Draft Environmental Impact Statement

Appendix N

Agency Coordination and Correspondence

Enclosed please find the complete package of responses to comment on the Clovewood DEIS received from the Village professionals Nelson, Pope and Voorhis (NPV); McGoey, Hauser and Edsall (MHE); Louis Berger (LB); Degenshein Architects (DA); and BAE Urban Economics (BAE); in August 2018 as follows:

Figure 1: CITY/SCAPE Phase IA APE (blue line)

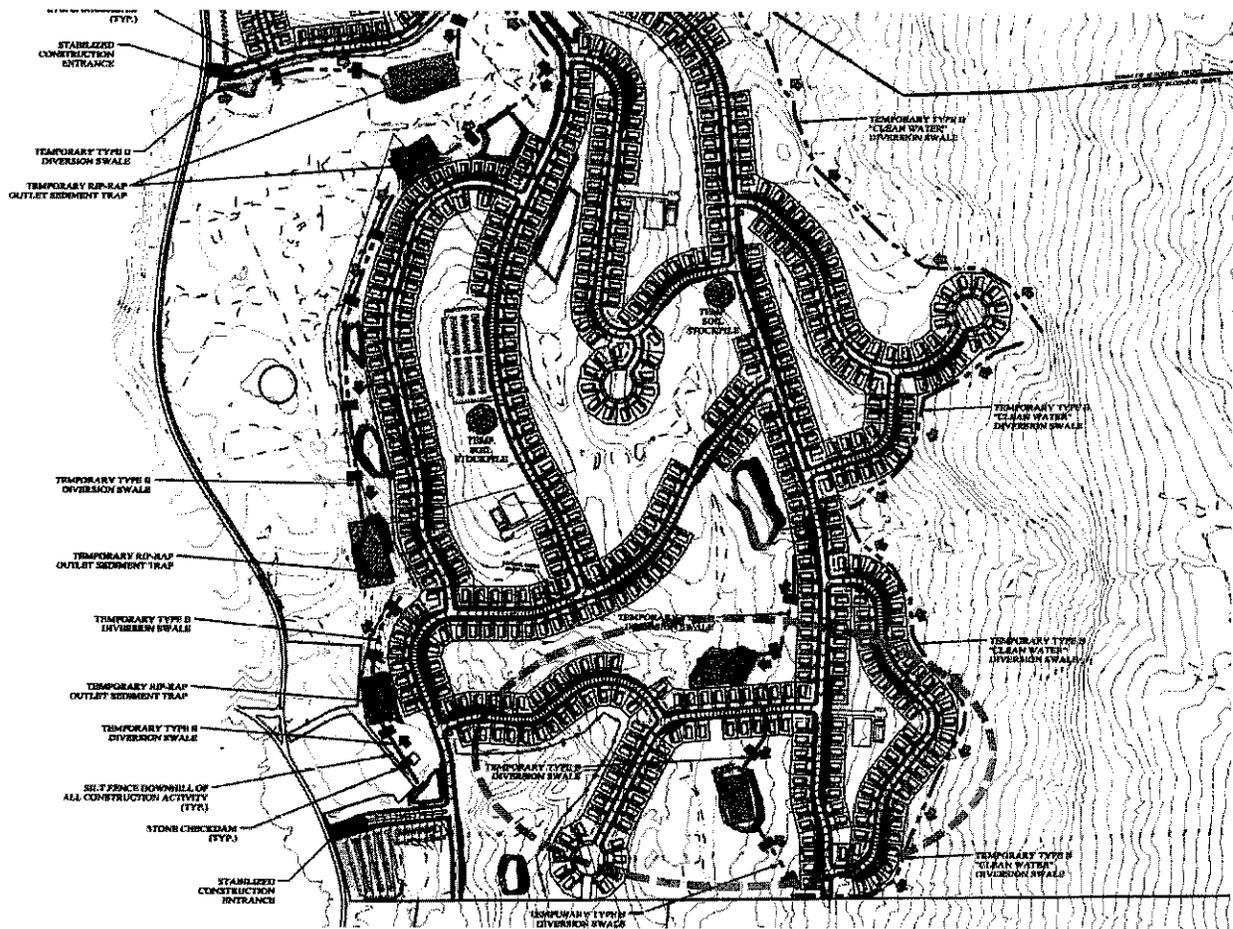
11. Delineation of the Area of Potential Effect (APE) large enough to account for all direct and indirect impacts of the project is critical to the evaluation of cultural resources. In this case the 136 acre APE determined in the 2015 CITY/SCAPE report (Figure 1) does not match the current site plan limits of disturbance. Specifically, as shown in Figure 2, the site plan has been modified to include additional development along the southern portion of the site that was previously proposed for parkland. The APE needs to be updated to reflect the current project. We request that a figure be prepared illustrating the revised APE in relation to the current site plan (as modified to address comments by others), specifically to include utilities work, the water tower and stormwater treatment areas. This will document that the APE boundaries are reasonable.

12. Once the APE is updated, the cultural resources technical studies need to be reevaluated by the Applicant's consultants. This may require additional Phase IB testing because the previous shovel test plan was based on the old APE (see in particular Appendix C to the Phase IB, showing no shovel tests in the southern portion of the site now proposed for development). The updated conclusions should be provided to OPRHP for review.
